Amendments to the Drawings:

REMARKS/ARGUMENTS

FIG. 1
Prior Art

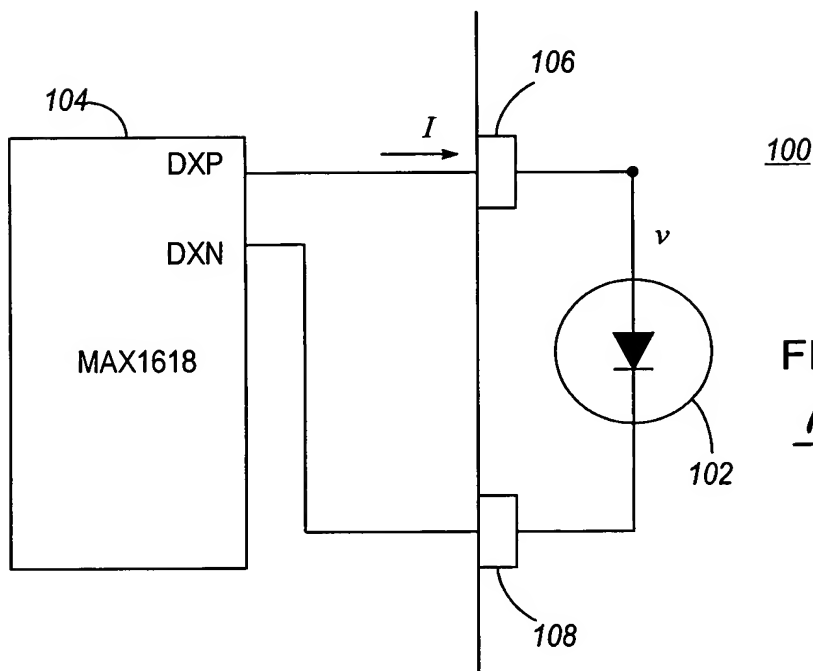
The Examiner objects to the drawings because FIG. 1 does not include a --Prior Art-- label. Applicants have amended FIG. 1 to include such a label, and this rejection is now believed to be moot.

The attached sheet of drawings includes changes to FIG. 1. This sheet, which includes FIGS. 1 & 3, replaces the original sheet including FIGS. 1 & 3. In FIG. 1, the label --Prior Art-- has been added.
